RHODE ISLAND CONTRACT No. 2019-CH-083

Old Tower Hill Rd (Rt 108 – Rt 1)

NOTICE TO PROSPECTIVE BIDDERS

ADDENDUM NO. 1 Prospective bidders and all concerned are hereby notified of the following changes in the Plans, Specifications, Proposal and Distribution of Quantities for this contract. These changes shall be incorporated in the Plans, Specifications, Proposal and Distribution of Quantities, and shall become an integral part of the Contract Documents.

RHODE ISLAND
 DEPARTMENT OF TRANSPORTATION
 IMPROVEMENTS TO
 OLD TOWER HILL ROAD
 SOUTH KINGSTOWN, RHODE ISLAND
 DRAINAGE AND UTILITY
 PLAN No.1

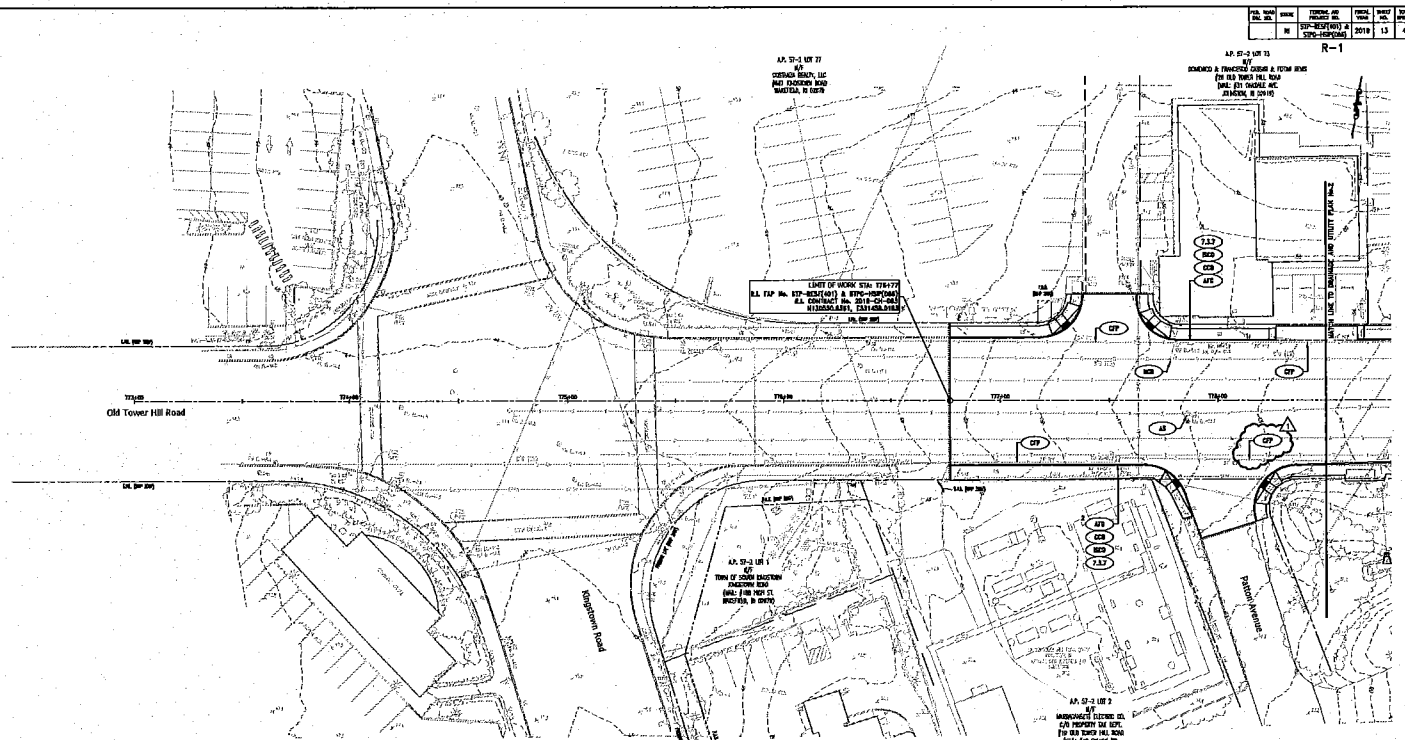
1. Replace Plan Sheet 13 with Sheet 13(R-1) attached to this Addendum #1. An additional limit for clean and flush pipe has been added.
2. Replace Plan Sheet 14 with Sheet 14(R-1) attached to this Addendum #1. An additional limit for clean and flush pipe has been added.
3. Replace Plan Sheet 16 with Sheet 16(R-1) attached to this Addendum #1. An additional limit for clean and flush pipe has been added.
